City of Pensacola

File #: 18-00304

PUBLIC HEARING: PROPOSED AMENDMENT TO THE LAND DEVELOPMENT CODE - CREATING SECTION 12-2-25, PROVIDING FOR THE CRA URBAN DESIGN OVERLAY DISTRICT

Table 12-2-25.3 -Single Family Detached and Two-Family Attached (Duplex) Residential Building Types- R-1AAA through R-1A

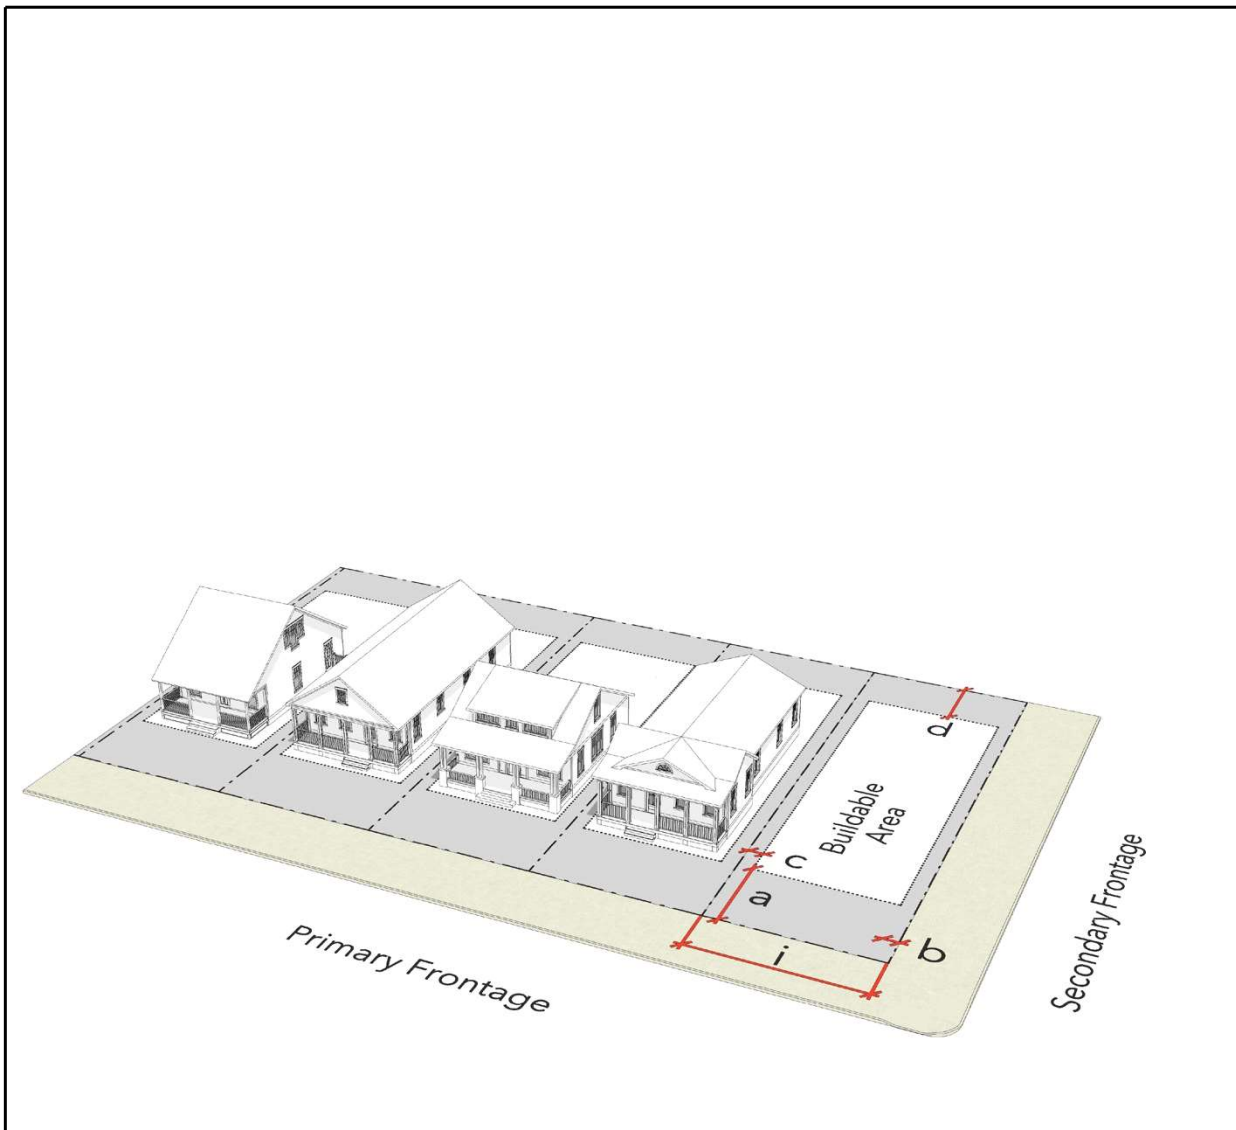
- c. Side and rear setbacks for single family detached and duplex developments on thirty-foot (30') lots should be reduced as follows:
 - a. Side setback reduction from five (5) feet to three (3) feet for single family detached and duplex buildings (Tables 12-2-25.3 and 12-2-25.4).
 - b. Rear setback reduction from 25-30' to 20' for single family detached and duplex buildings (Tables 12-2-25.3 and 12-2-25.4).

- (1) Measured according to Section 12-2-25(G)(a)(c).
- (2) See Section 12-2-25(G)(h)(b) for exceptions.
- (3) Lot width shall only be measured from the right-of-way line. Lot width at the building setback
- (4) [Minimum side yard setback for thirty-foot \(30'\) lots shall be three \(3\) feet measured from the required per applicable Florida Building Code.](#)
